CHANGES FROM BASE PRODUCT VBV-790C-C(3346D) TO VBV-790C-C(CO)(5495A).

Assembly Pl Approval T. DEAN 21/10/20		Approved by B.CHILDS		Checked by A.FOSTER		Drawn by J. TYRRELL	
Angle of Projection		Units mm	Scale N/A	Released 23/10/20		Assembly Ref -	
		Status RELEASED		VBV-790C-C(CO)			
Third Angle		Part No 5495A		BE-004404-00-20

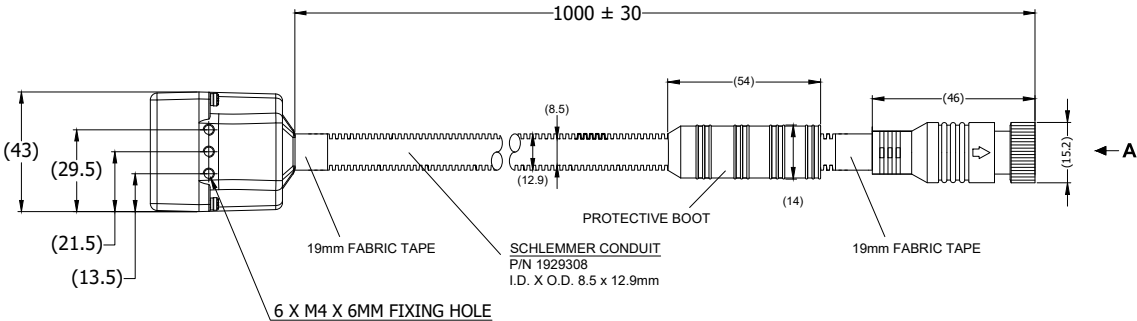
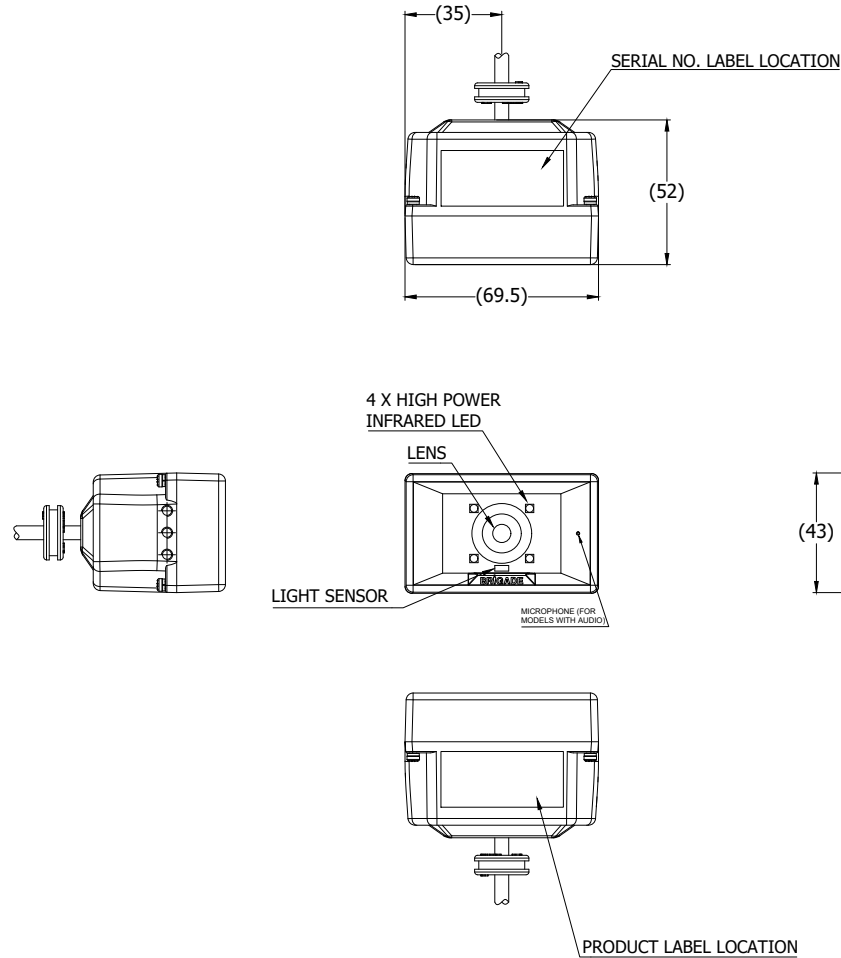
- CHANGE:
- 1. VBV-790C-C PD LBL REPLACED WITH VBV-790C-C(CO) PD LBL.
 - 2. REMOVE GROMMET.
 - 3. CONDUIT ADDED TO CABLE.
 - 4. FABRIC TAPE ADDED TO EITHER END OF CONDUIT.
